Stag Brewery, Mortlake

ES Statement of Conformity Note – Light Pollution

Document Reference: WIE18671-114-TN-230515_ES SoC Note_Light Pollution

Drawing no. 2201-LP02

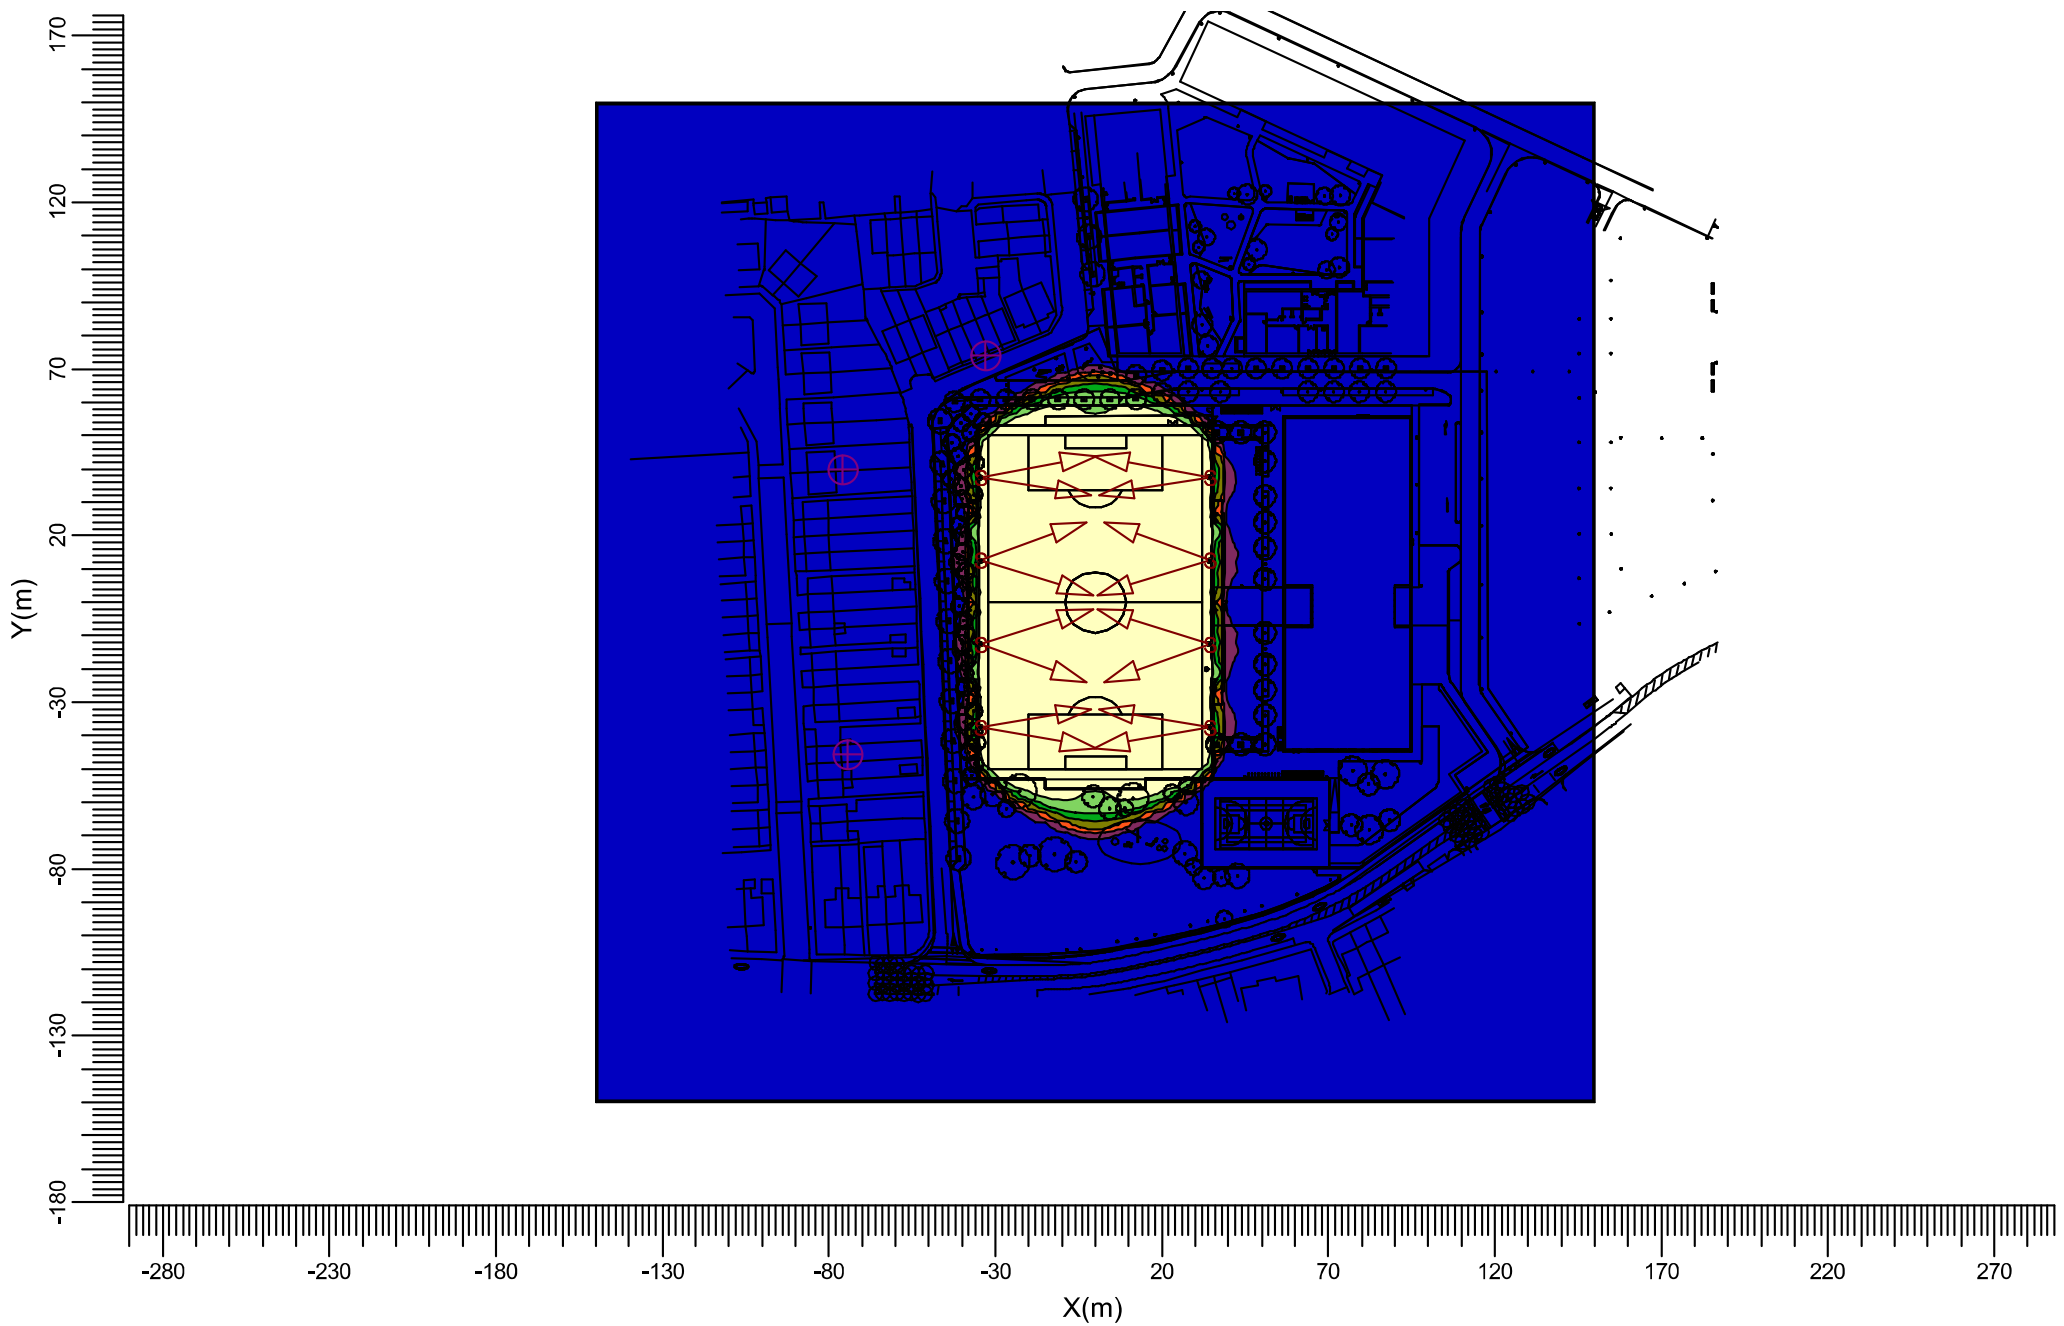
The ES states the following – can you confirm this still applies. Also, where does the guidelines state 10,000?

“Paragraph 18.180 of the March 2022 ES Chapter 18: “In addition to light trespass, Luminaire Intensity (glare) has been considered as is recommended for floodlights. This assessment considers 3 assessment points located at the windows at the residential properties across Williams Lane. In each case the Luminaire intensity would not exceed 1,000 lumens. This is well below the suggested 10,000 Lumens suggested as the maximum pre curfew levels.”

- 2.1. Paragraph 18.180 of 2022 ES Chapter 18 is no longer relevant given the Institute of Lighting Professionals (ILP) Guidance: The Reduction of Obtrusive Light was updated in 2021. As such, the light pollution analysis produced by Michael Grubb Studios, and submitted as a standalone planning document, was updated in April 2023 (document refs: 547-(010)-RP-EX-LA-B Sports Pitch Lighting Assessment (Section 01) 220414 & 547-(010)-RP-EX-LA-B Sports Pitch Lighting Assessment (Section 02) 220414). To demonstrate the conclusions of the assessment presented in 2022 ES Chapter 18 do not change, the Light Pollution section of Chapter 18 of the March 2022 ES and ES Appendix 18.5: Light Pollution have been updated in line with this new guidance / new analysis (refer to **Annex 1 and 2**) and supersede the March 2022 versions.

- 2.2. As noted at paragraph 18.174 of ES Chapter 18 (both the March 2022 and the updated version), it is important to note that the final and fixed lighting scheme has not yet been developed and instead a provisional lighting scheme has been produced by Michael Grubb Studios. The primary update to the ES Chapter includes the removal of the references to light ‘trespass’ and instead referenced as light ‘spill’, together with further descriptions to the environmental zones (as described in updated paragraph 18.37 and Table 18.1 of ES Chapter 18). In addition, eB7 have omitted the criteria for Sky Glow and Building Luminance from the methodology (amended paragraph 18.35 of ES Chapter 18) as these tests are not relevant for the Development. With regard to the technical assessments, the analysis for light spill remains in line with the previously submitted analysis. For glare, the analysis continues to show no visible glare beyond curfew when the fittings are off and negligible amounts visible when the fittings are on upon the neighbouring properties (as updated in paragraph 18.180).

- 18.179 The fitting suggested are Philips Lighting 'OptiVision' floodlights. These floodlights include internal louvres that are used to control light spill to neighbouring residential properties, ensuring that the maximum value at neighbouring receptors is below what is an acceptable level for E3 Environment Zone (pre-curfew - 10 lux and post curfew 2 lux) for both schemes. This ground level light spill grid can be seen in drawing 2201 – LP2 and 2201 – LP3 respectively within **Appendix 18.5** which shows the light levels in lux mapped onto the pitch and surrounding area. The light spill on the façades for the FA class III scheme (120 Lux) are shown in drawings 2201 – LP04 (houses to the west) and 2201 – LP06 (houses to the north west). The light spill on the façades for the Class II scheme (200 Lux) are shown in drawings 2201 – LP05 (houses to the west) and 2201 – LP07 (houses to the north west). The assessment of vertical illuminance to the windows at the rear of the properties across Williams Lane shows that levels as a result of the flood lights would not exceed 0.2 Lux when in use (shown in drawings 2201-LP02 and 2201-LP03 within **Appendix 18.5**).
